HOLDOVER
Revised
MYRTLE ACRES SUBDIVISION

APPLICATION NUMBER Holdover DATE April 6, 2006

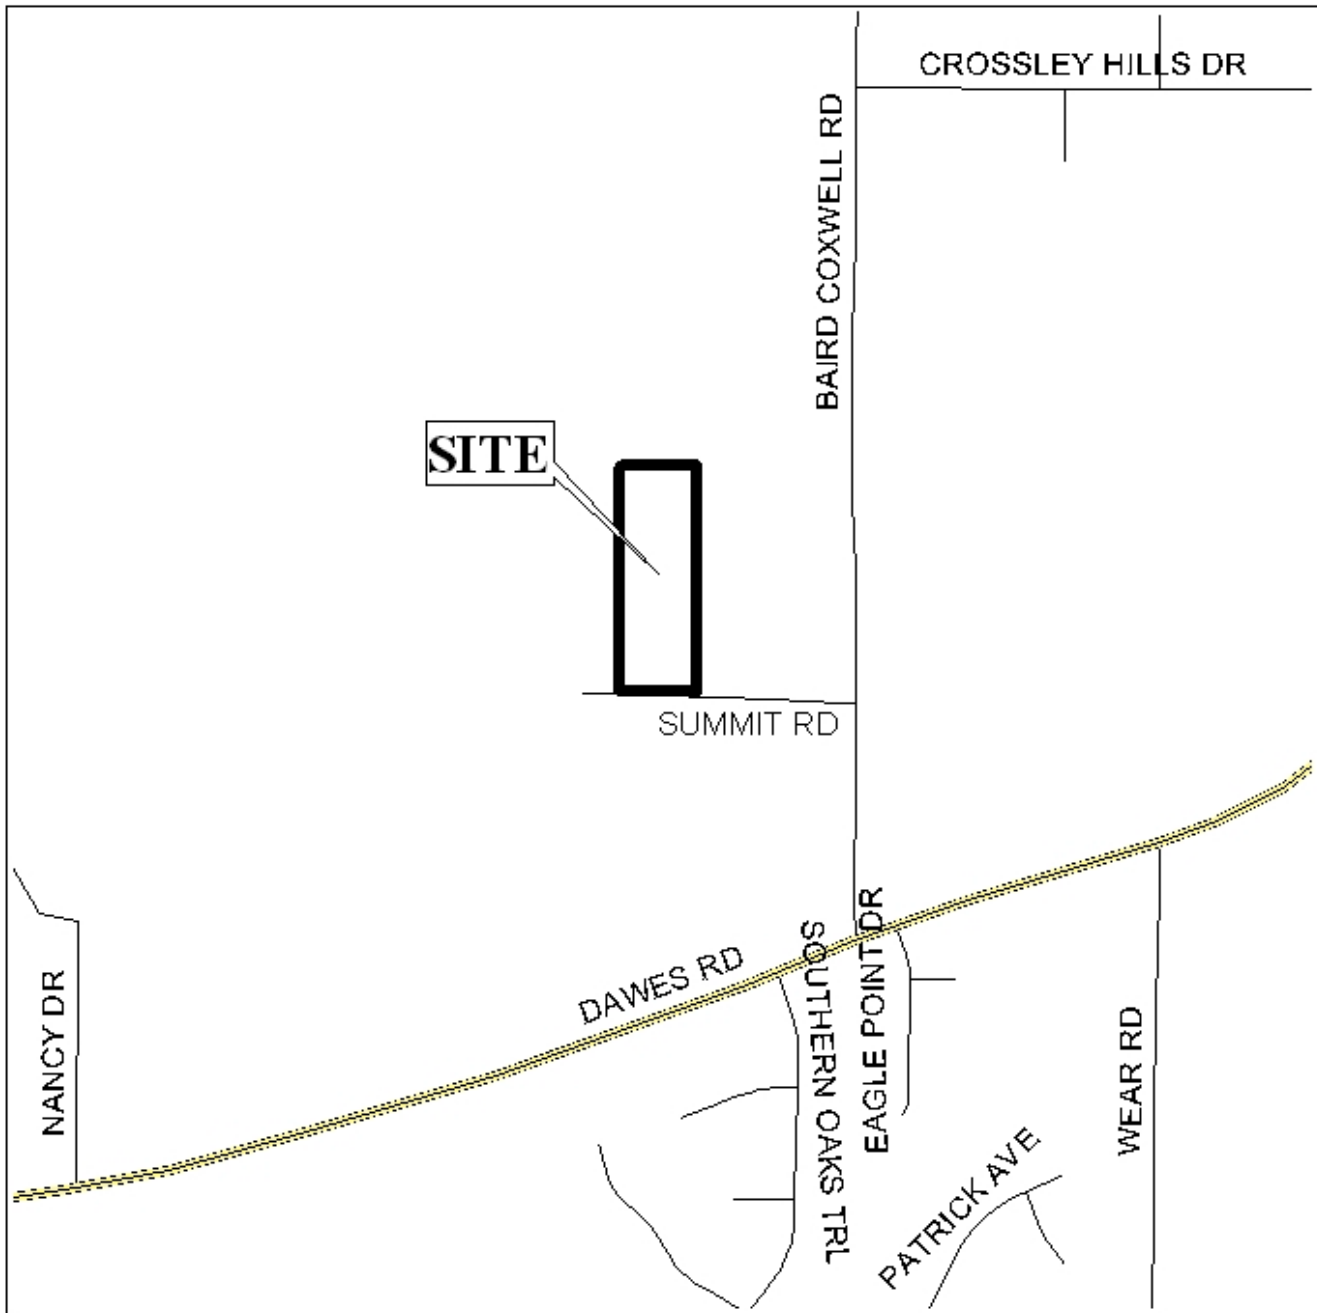
The purpose of the application is to create a two-lot subdivision from a lot of record. The site fronts Summit Road, a County-maintained dirt road with a 50-foot right-of-way. For this reason, a note should be placed on the final plat stating that there will be no further subdivision of the site until Summit Road is improved to County Engineering standards.

The site adjoins two landlocked parcels to the North that are combined with the subject parcels (in North-South pairs) in tax records; these parcels should be brought into the subdivision. While the resulting lots would exceed the maximum depth-to-width ratio of the Subdivision Regulations, this would resolve the current issue of the landlocked parcels. While the site would then adjoin more landlocked parcels, those are under separate ownership, and no roads are proposed, so their inclusion in the subdivision would not be required.

The site is located in the County; thus any lots that are developed commercially and adjoin residentially developed property must provide a buffer, in compliance with Section V.A.7 of the Subdivision Regulations.

The required 25-foot building setback lines will also be required on the final plat.

Based on the preceding, this application is recommended for holdover to the April 6th meeting, to allow the applicant to include the two landlocked parcels to the North. Revised drawings, additional mailing labels, and additional mailing fees should be received in Urban Development by March 13th to be considered.

This application was held over from the March 2nd meeting to allow the applicant to include two landlocked parcels to the North. These have been included in revised plats, and, with a waiver of Section V.D.3 (maximum depth), will meet the minimum requirements of the Subdivision Regulations.

Based on the preceding, it is recommended that Section V.D.3 (maximum depth) be waived and the plat granted Tentative Approval, subject to the following conditions: 1) the placement of a note on the final plat stating that there will be no further subdivision of the site until Summit Road is improved to County Engineering standards; 2) the placement of a note on the final plat stating that any property that is developed commercially and abuts residentially developed property shall provide a buffer in compliance with Section V.A.7 of the Subdivision Regulations; and 3) the depiction of the 25-foot building setback lines on the final plat.
